Action Transmittal

Action Transmittal: 2024-05

Scope Change Request for Saint Louis Park Cedar Lake Road and Louisiana Avenue Improvements Project

RE: Scope Change Request for SP 163-296-006 & SP 163-296-007

LOUISIANA AVE IMPROVEMENTS - CITY PROJECT NO. 4024-1100

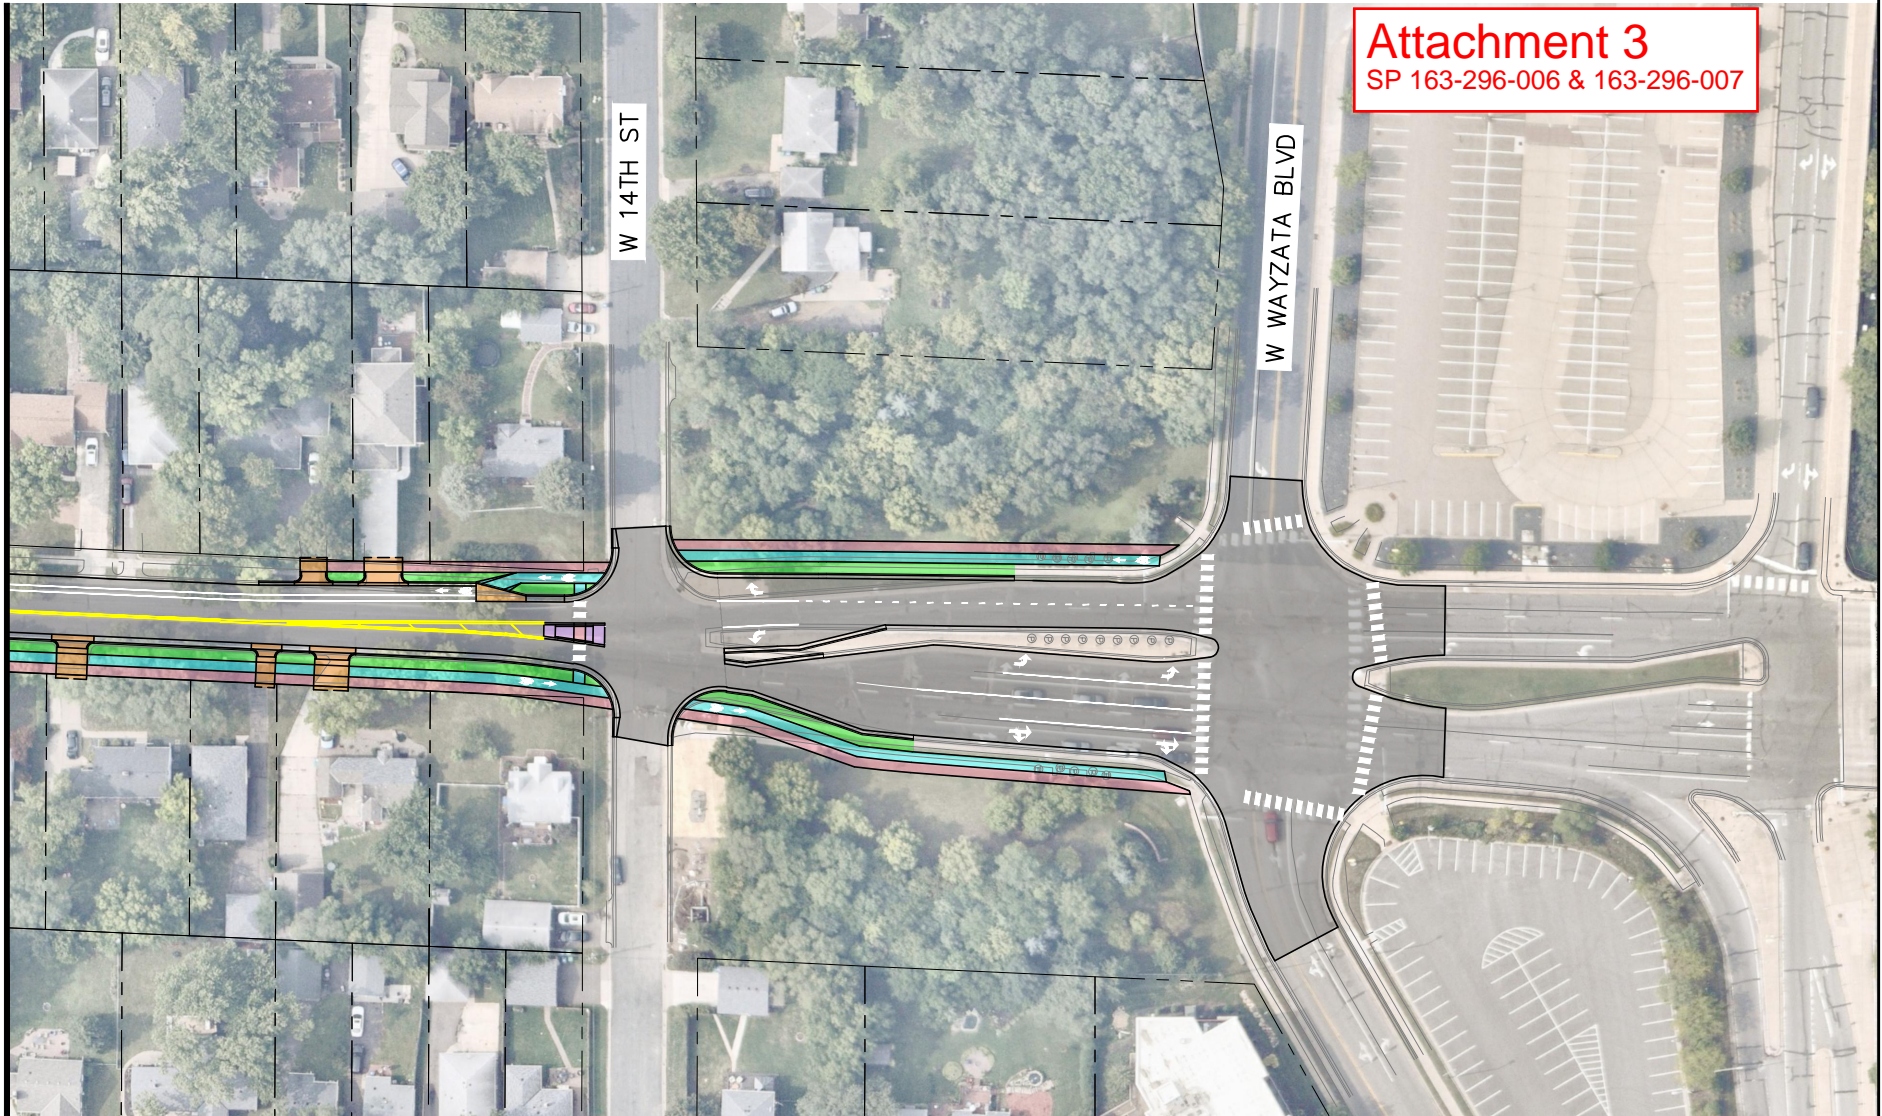
application design. The formal scope change for Louisiana Avenue includes modifying the bicycle facility as described in the table below and shown in Attachment 4 and Attachment 5.

Louisiana Avenue Bicycle Facility Summary		
Location	Funding Application Design	Current Design
Louisiana Avenue: 23rd Street to Cedar Lake Road (400 feet)	Protected one way cycle track in each direction Sidewalk on both sides of the road	Shared use trail on both sides of roadway
Louisiana Avenue: Cedar Lake Road to 22nd Street (900 feet)	Dedicated on street bike lanes or protected one way cycle track in each direction Sidewalk on east side of the road	Shared use trail on west side of roadway Sidewalk on east side of the road
Louisiana Avenue: 22nd Street to 14th Street (2500 feet)	Dedicated on street bike lanes or protected one way cycle track in each direction Sidewalk on east side of the road	*Dedicated bike routes using parallel side streets and trail Sidewalk on east side of the road
Louisiana Avenue: 14th Street to Wayzata Blvd (300 feet)	Protected one way cycle track in each direction Sidewalk on east side of the road	Shared use trail on both sides of roadway

LOUISIANA AVENUE ROAD IMPROVEMENTS
CITY PROJECT NO. 4024-1100
GEOMETRIC LAYOUT
NOVEMBER 2023

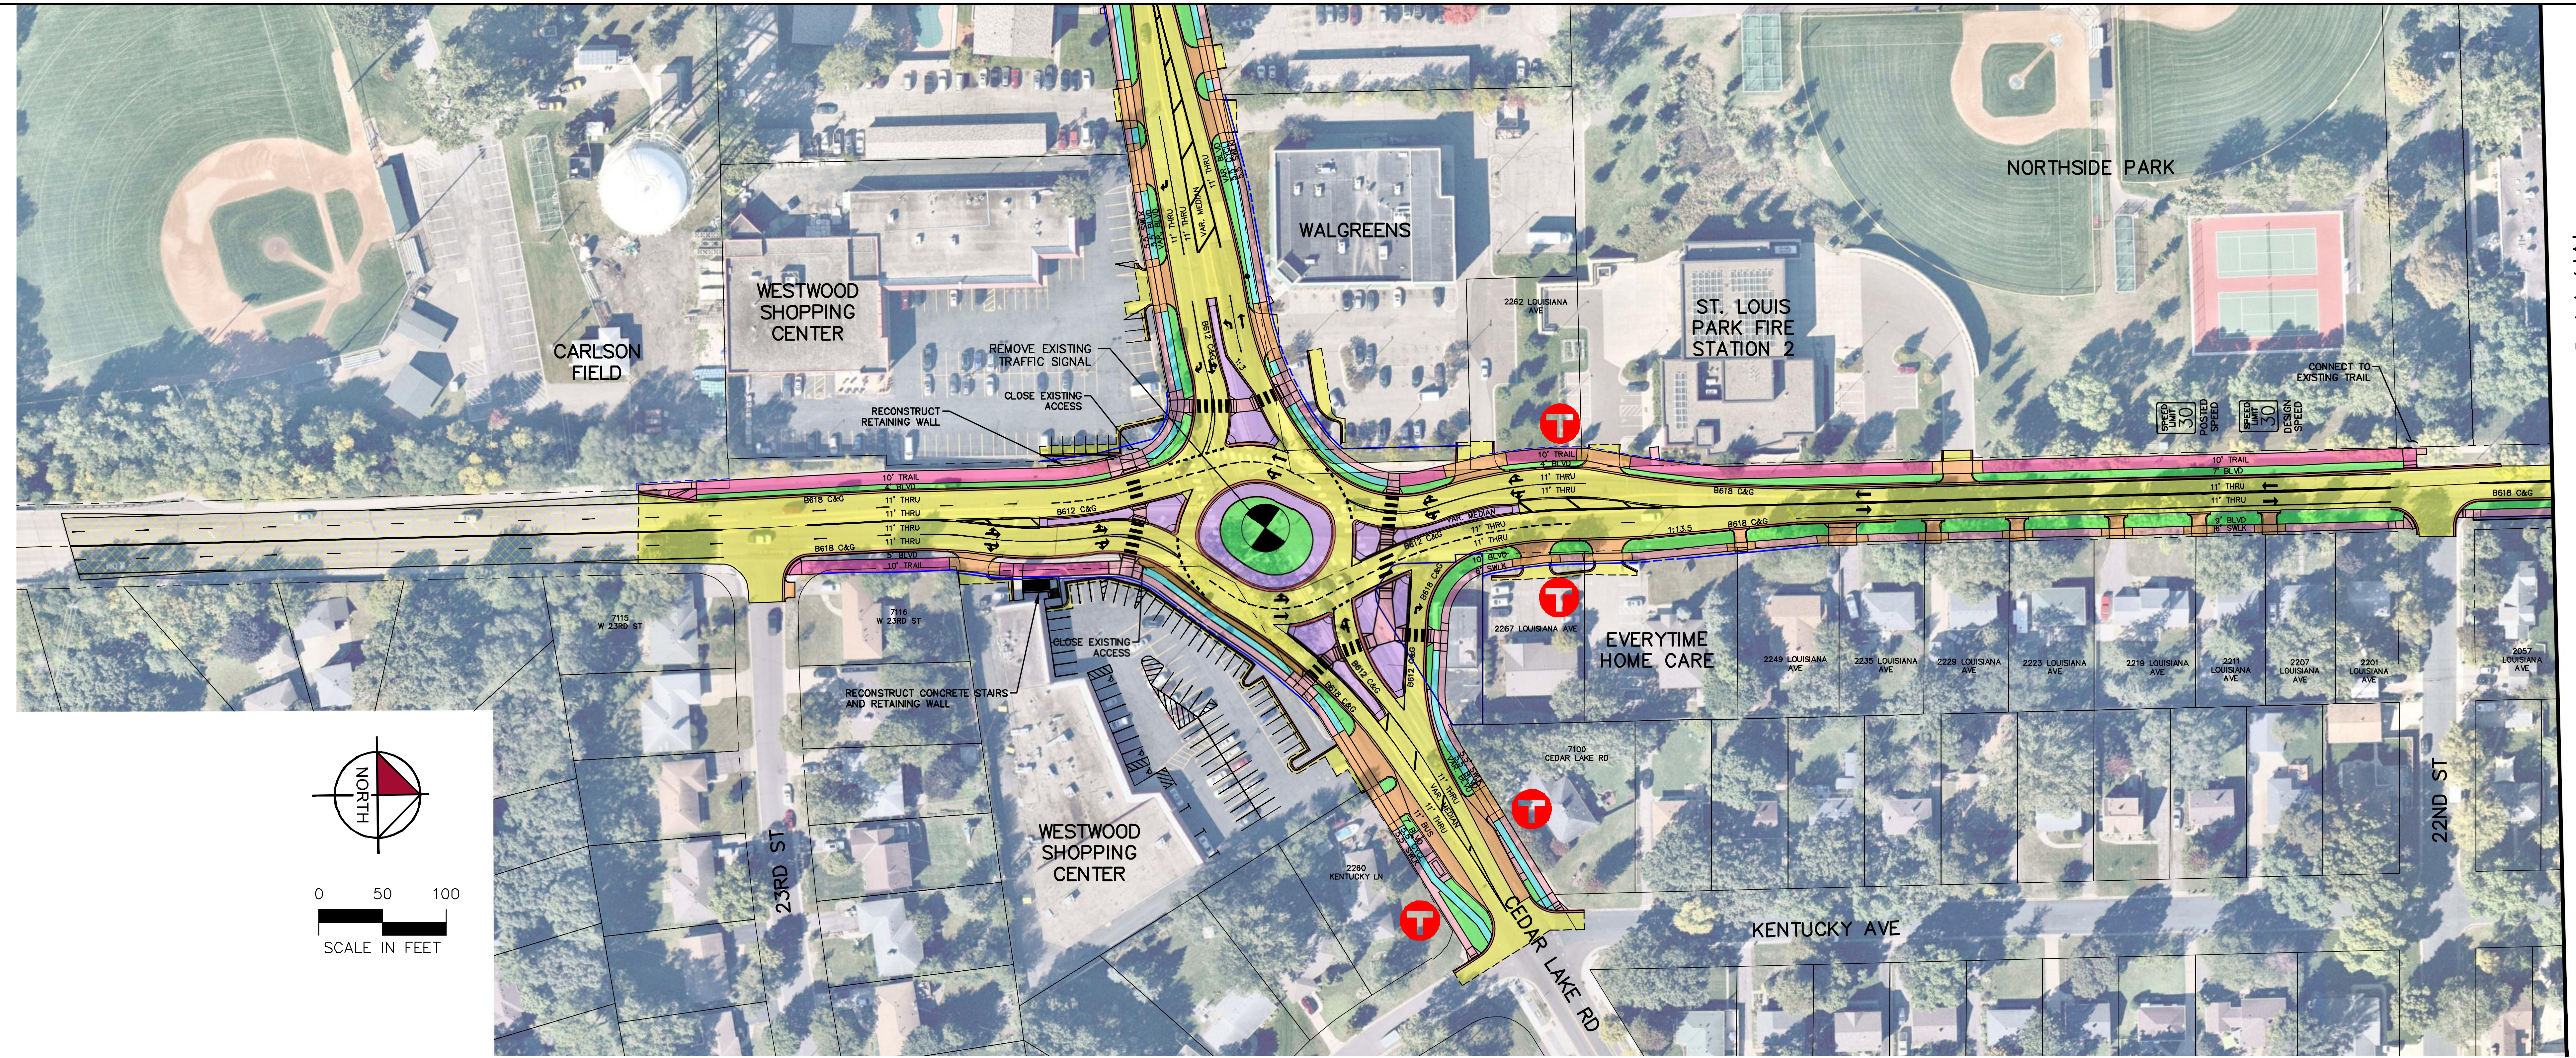
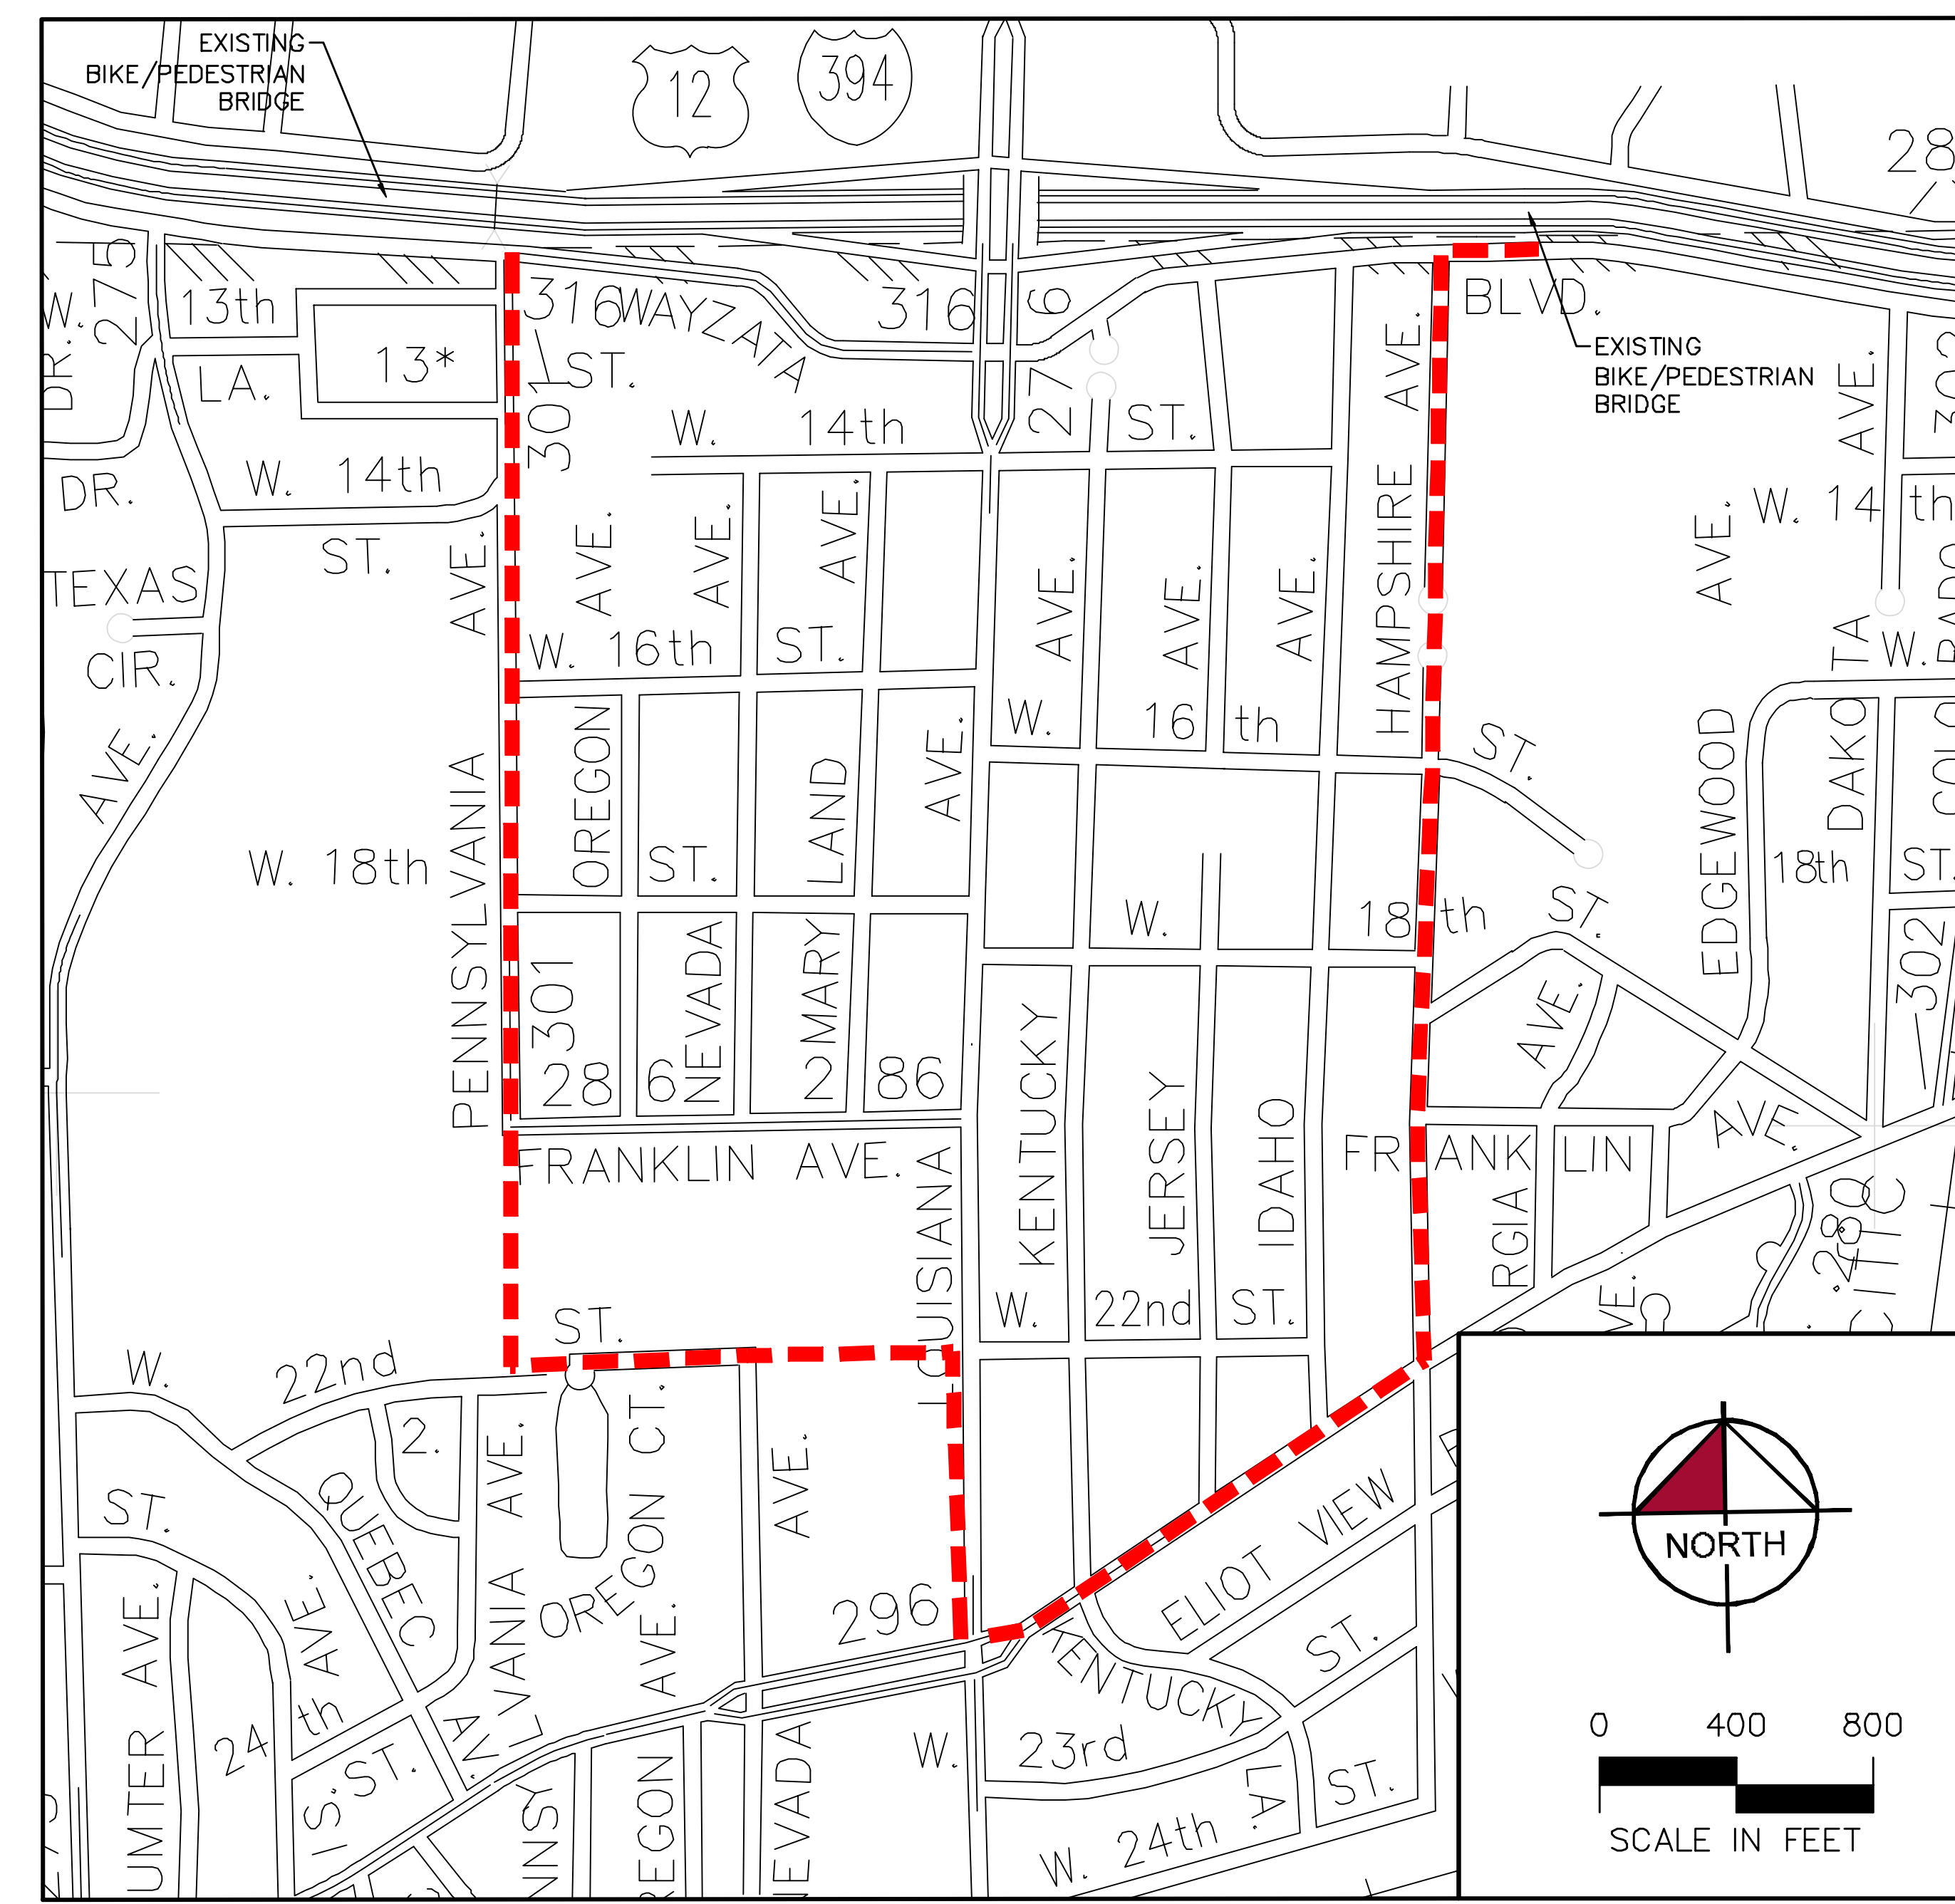
*Dedicated bike routes on parallel side streets include Hampshire Avenue, approximately 1300 feet (4 blocks) east of Louisiana Avenue and Pennsylvania Avenue, approximately 1350 feet (4 blocks) west of Louisiana Avenue. These alternate bike routes are shown as red dashes in Attachment 5 on the "Alternative Bike Route Map".
